Giant Mine Environmental Assessment

Round One: Information Request - Review Board #16

EA No: 0809-001

Information Request No: Review Board #16

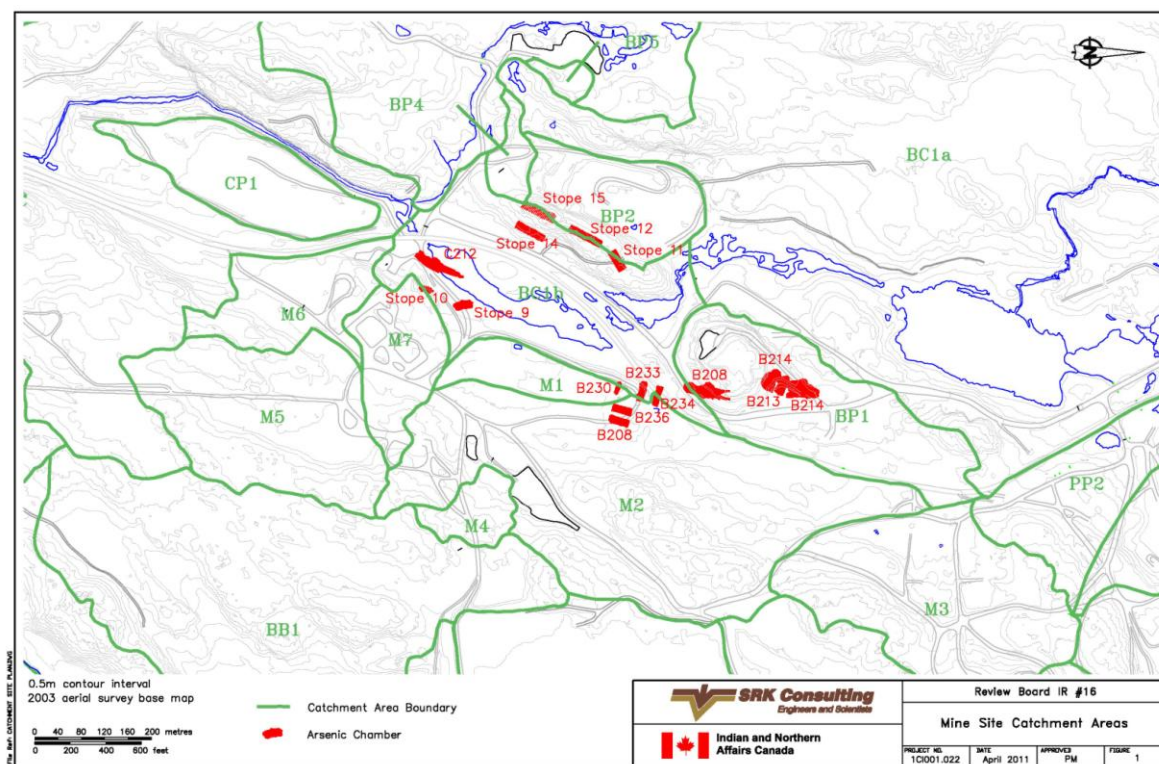
1. Please verify possible deformations during the freezing process, such heave, differential freezing etc.
2. Please compare deformations to natural drainage patterns and check alterations.
3. Please describe potential impacts of instability or failure of crown pillars and bulkheads due to differential expansion and other changes that may occur during freezing.
4. Please describe potential impacts of instability or failure of crown pillars and bulkheads due to thawing and reductions of pressure.

The figure below shows the location of the chambers in relation to the current drainage patterns on site. The catchment areas correspond to those used in the water and load balance reported in Supporting Document M1 of the Giant Mine Remediation Plan. Table 5.1.7 of the DAR discusses concerns about the stability of crown pillar over stopes B208, B212, B213 and B214. All of those stopes are located in the B1 Pit catchment area. Even a complete crown pillar failure would have no impact on drainage patterns outside this catchment area. Drainage patterns within the B1 Pit catchment will be significantly modified by the pit backfilling, and any required re-grading could be accomplished at that time. It should be noted however that the plan is to backfill the voids beneath the crown pillars in order to prevent crown pillar failure.
